Special Environment Intel386™ EX Embedded Processor B-Stepping Device Errata and Feature Enhancements

Presented in this document are known errata for the B-1 step production version of the Special Environment 80386EX embedded processor. (Any processor marked with the DESC number, 5962-9557001xxx, is a B-1 step production part.) A workaround, if known, is also presented. This document will be updated as time progresses to either indicate new errata or to indicate additional workarounds.

Errata #14, BIU

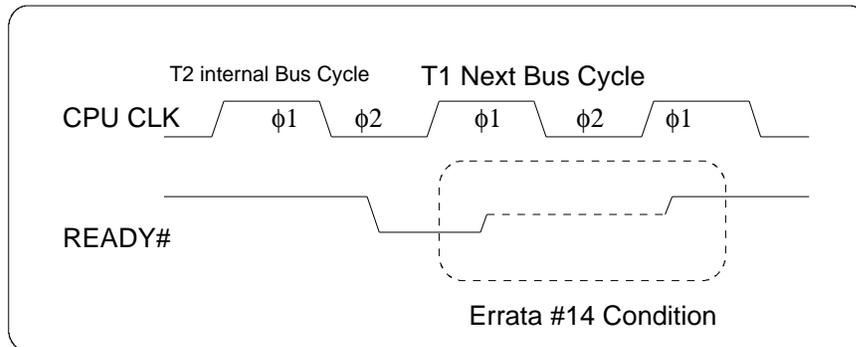
READY# floats in T1 after internal bus cycle

During internal bus cycles, the LBA# signal does not remain active into the next T1 bus state, causing READY# to float during T1. This is unlike bus cycles controlled by the CSU, where READY# is driven inactive during T1 of the next bus cycle.

Pull-up READY# if the float condition will cause system logic to operate improperly.

Errata #24, SSIO**TEN bit in SSIOCON1 register turns off transmit channel too soon****Reported 10.7.94****Stepping Fix: C****Description:**

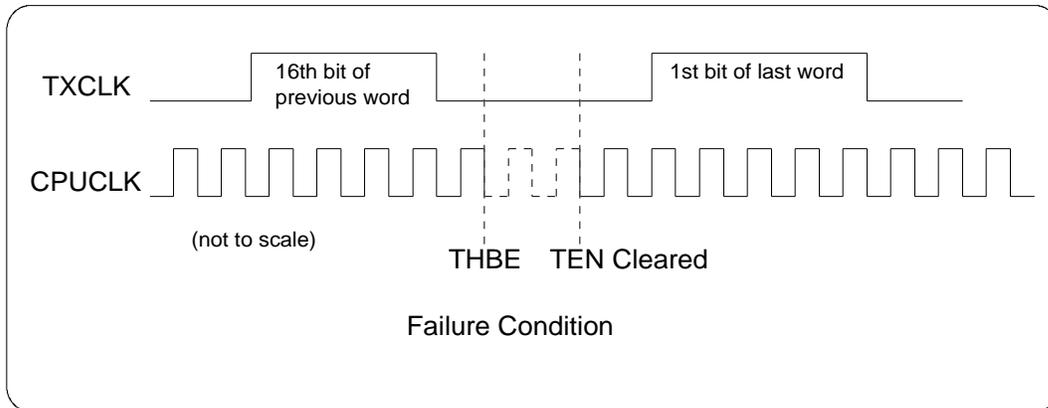
When the SSIO is transmitting data (master or slave mode) the transmitter is turned off by clearing the TEN bit of the SSIOCON1 register. One way of indicating to the software to clear this bit is by waiting for the Transmit Holding Buffer Empty (THBE) signal to go active, indicating that the word written to the holding register is ready for transmission from the shift register. Even if the software waits for this signal and then writes to SSIOCON1 to disable TEN, depending on when TEN is cleared, the last word transmit may or may not take place.

If the TXCLK is significantly slower than the CPUCLK, then it is possible for the THBE bit to be set and the TEN bit to be cleared all during the low time of the TXCLK (see diagram). In this case, even though the last word to be transmitted has been loaded into the shift register, it will not be shifted out.

In order to assure that the last word is transmitted, the TEN bit must not be cleared until after the TXCLK transitions from low to high when the 1st bit of the last word is being transmitted. Consequently, the way to assure that this happens is to either: 1) utilize a timer to assure that enough time elapses from when the THBE bit goes high until the TXCLK goes high, or 2) execute a fixed number of NOPs after THBE goes high before clearing TEN. In either case, the length of the delay is dependent upon the frequency of TXCLK and the CPUCLK.

Errata #29, BIU

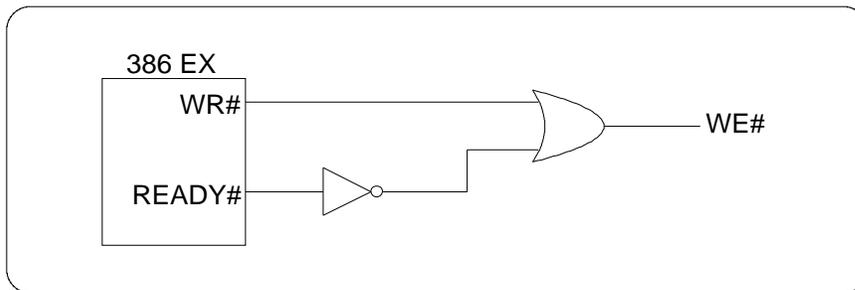
Insufficient Address Hold Time after WR# goes high.

The address hold time after WR# goes high does not meet the data sheet spec of 5nS.

The circuit shown below may be used to generate a write strobe if the READY# signal is not generated too early in the T2 cycle. Please note this circuit has not been tested in a real design and is provided as an example only. For applications cannot use the circuit below it is necessary to implement an external WE# signal using a simple state machine design. An example of what that state machine could look like is available in the EV386EX evaluation board design, or in the Point of Sales Terminal reference design available from the BBS or through literature.

Errata #30, BA

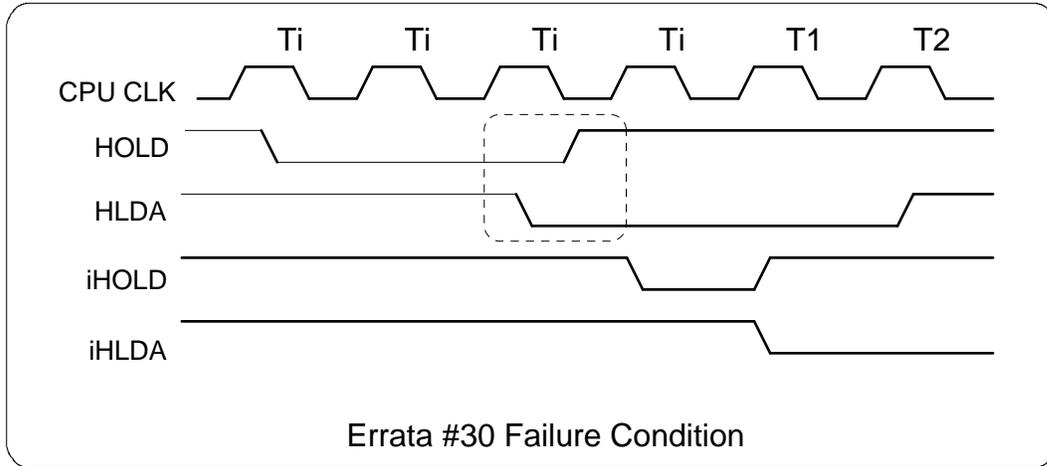
In a HOLD/HLDA cycle the HOLD signal must not be re-asserted until after HLDA is returned inactive. If, however, HOLD is asserted in the same T-state that HLDA goes inactive a problem may occur where the bus arbiter relinquishes control to the core and at the same time floats the bus by asserting the HLDA pin. The following waveform shows the conditions that cause this error. The signals iHOLD and iHLDA are internal signals and represent the HOLD input to the core and the HLDA output from the core (equivalent to the HOLD and HLDA signals on a 386SX processor). In this diagram a T1 occurs because a request was pending by the core during the previous HOLD cycle. One T-state after the arbiter releases the bus (HLDA = 0) it removes its iHOLD, and then the core removes iHLDA. As soon as the iHLDA is released the T1 state starts. However,

because of the timing of the next HOLD request, the bus arbiter re-asserts iHOLD and HLDA even though the core has not asserted iHLDA. The result is that the core continues to run its bus cycle and, at the same time, the bus arbiter has floated the external bus.
